# UNITED STATES PATENT AND TRADEMARK OFFICE

10/692,865

Toshihito Yanashima

<b>Office Action Summary</b>	<b>Application No.</b>	<b>Applicant(s)</b>	
	10/692,865	YANASHIMA ET AL.	
	<b>Examiner</b>	<b>Art Unit</b>	
	Nguyen N. Hanh	2834

FIG. 30

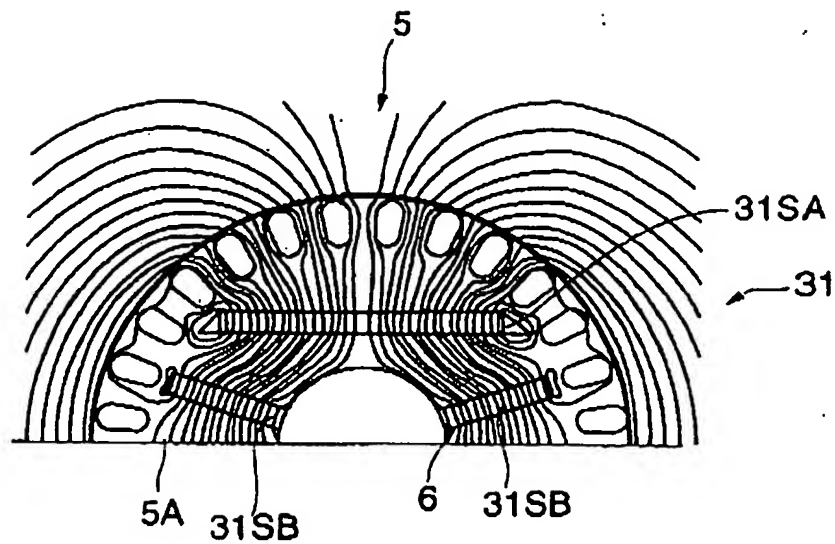
1. In view of amendments, the Examiner withdraws the objection to the drawings with reference to Fig. 30. However, Applicant's argument necessitated new ground of objection.

2. The drawings are objected to under 37 CFR 1.83(a). The drawings must show every feature of the invention specified in the claims. Therefore, the features "a permanent magnet embedded in the rotor yoke which does not have a length radially disposed; and secondary permanent magnets each having an arcuate shape curving around the rotating shaft" must be shown or the feature canceled from the claims 16-18. It is noted that none of the Figure of the present invention show two kind of permanent magnet in which the secondary magnet having an arcuate shape curving around the rotating shaft. Only Fig. 42 shows one kind of permanent magnet having an arcuate shape curving around the rotating shaft. In lights of the drawings and the specification, the Examiners interprets the feature recited in claims 16-18 as readable to Fig. 30 of the present invention

Regarding claims 16-18, Applicant's disclosure (drawings and specification) fail to show "a (first) permanent magnet embedded in the rotor yoke which does not have a length radially disposed; and secondary permanent magnet each having an arcuate

shape curving around the rotating shaft...". As previously discussed in the objection to the drawings, only Fig. 42 of the present invention show one kind of permanent magnet each having an arcuate shape curving around the rotating shaft". Therefore, the Examiner interprets the limitations as readable to Fig. 30 of the present invention and all the limitations of claim 16-18 have been fulfilled by Naito et al. and Liu et al. For the reasons explained above, the rejection is still deemed proper.
